ADDENDUM NO. 6

Kalida's Riverbend Nature Area Canoe & Kayak Landing VILLAGE OF KALIDA, OHIO

Date Issued: Friday, February 6, 2026

Title:
TIMBERFORM METAL BOLLARDS
MODEL NO. 2190-RH
REMOVABLE BOLLARD
WITH HASP/HOLE COVER

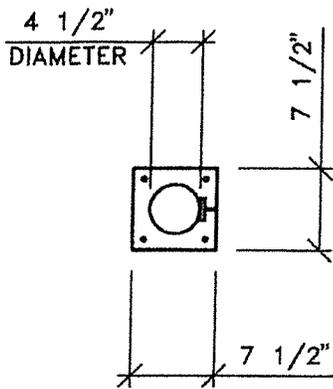
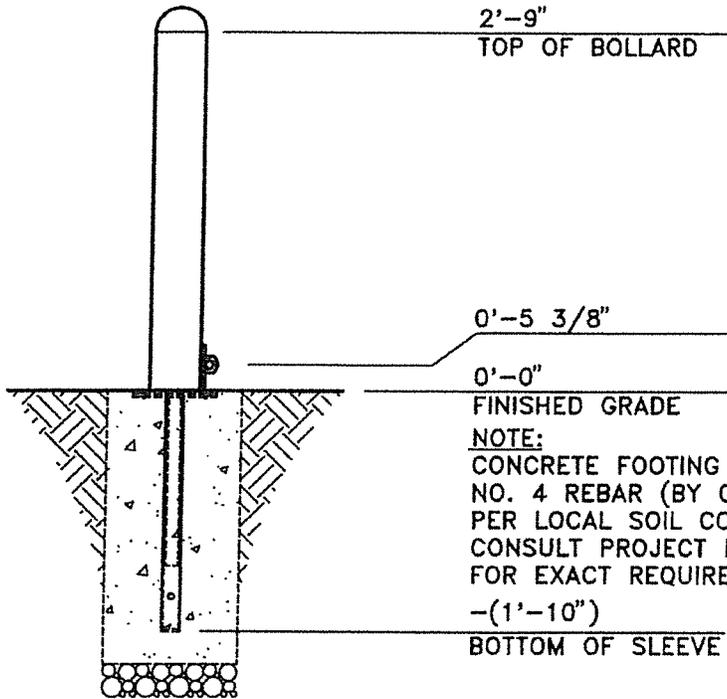
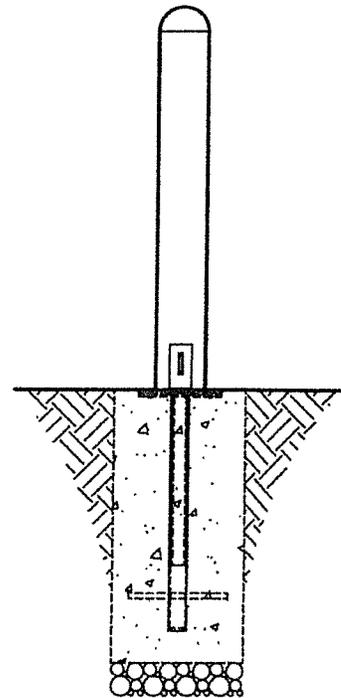
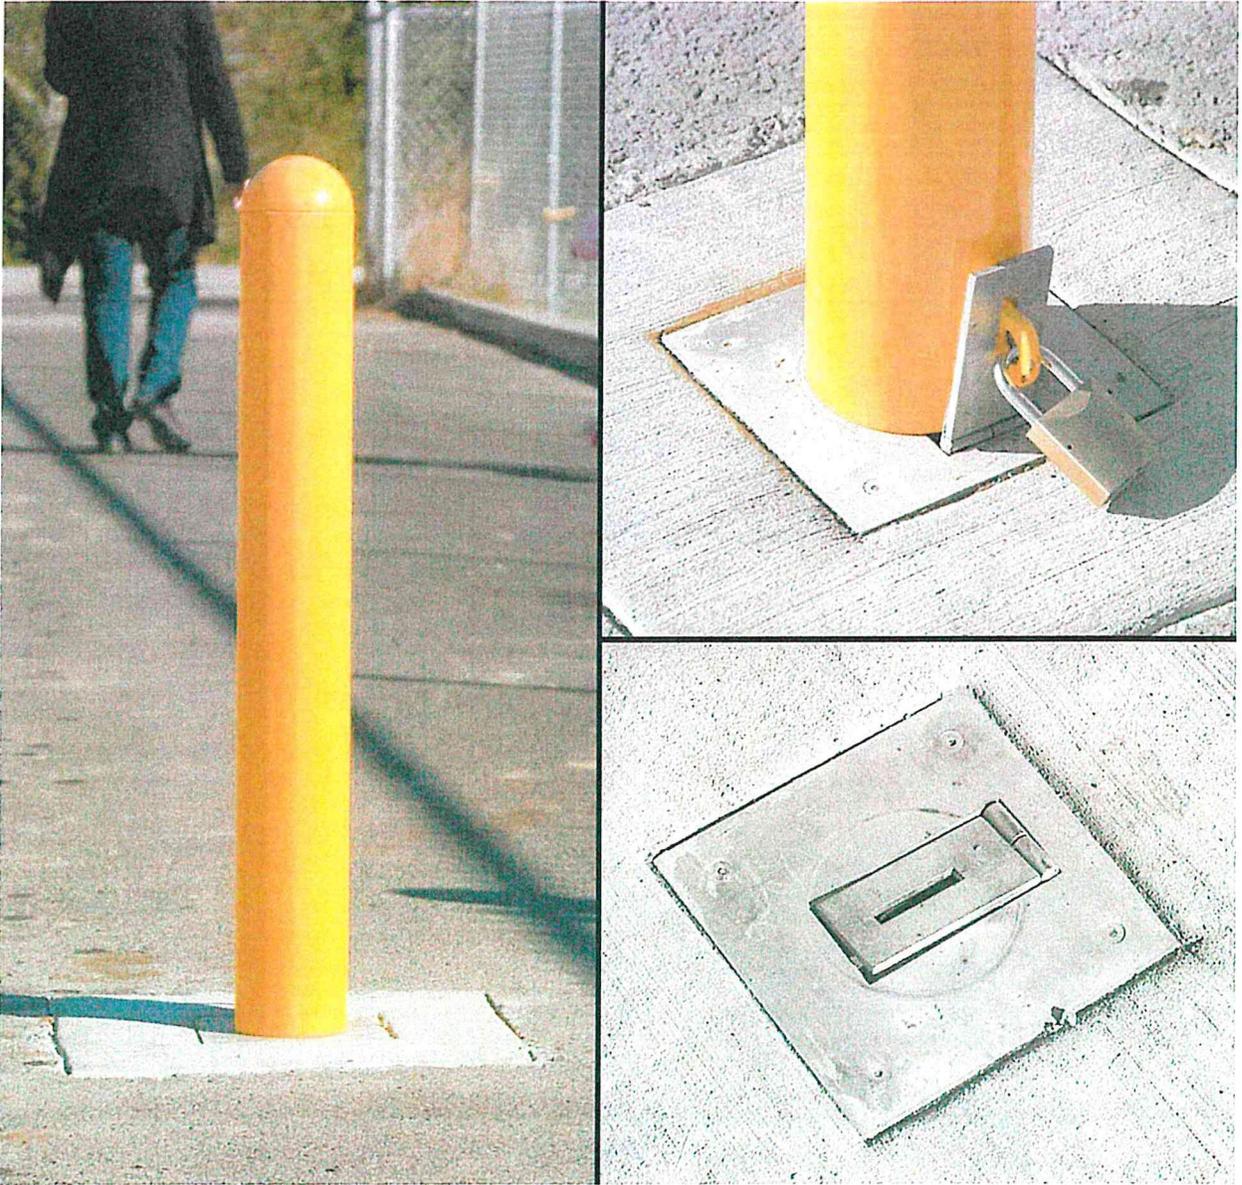
Revision #3 – Concerning Bid Item #42, a 3 page detail for the removable bollards is attached as a part of this Addendum #6.

Removable Bollard shall be TimberForm® model No. 2190-RH in yellow color finish as selected by the owner's representative and in the quantity shown on the bill of materials or the project drawings. Manufacturer, Columbia Cascade Company, 1300 SW Sixth Avenue, Suite 310, Portland OR 97201-3464 U.S.A. or Approved Equivalent.

Bollard post shall be 4 inch i.d. schedule 40 mild steel pipe with a minimum wall thickness of 7/32 inch with a 1 inch schedule 40 mild steel pipe permanently and 1/4" steel lock hasp welded to bottom. *Thin wall tube is not acceptable.* Top of bollard post shall be fitted with a cast aluminum hemi-dome end cap, permanently adhered in place. *Easily vandalized friction fit end caps are not permitted.*

Embedded sleeve assembly shall include a 1-1/4 inch i.d. schedule 40 mild steel pipe permanently welded to a 3/16 inch mild steel plate, a notched 3/16 inch mild steel plate and a hinged cap assembly consisting of a 1/4 inch steel plate and hinged door. Bollard post and embedded sleeve shall interlock for padlock (by others). Embedded sleeve shall include two 9/16 inch diameter thru holes for No. 4 re-bar (by others).

Bollard post shall be a single unit. Embedded sleeve shall attach to notched plate and hinged cap assembly with tamper-resistant 1/4 inch flat head hex socket machine screws, cut washers and ESNA lock nuts. Final product shall be free of burrs.

Steel and cast iron parts shall be coated with CASPAX-7™, a tough, opaque, UV resistant exterior grade polyester powder coating applied to a minimum thickness of 6 mils. *Liquid, epoxy or lead-containing powder coatings are not acceptable.*
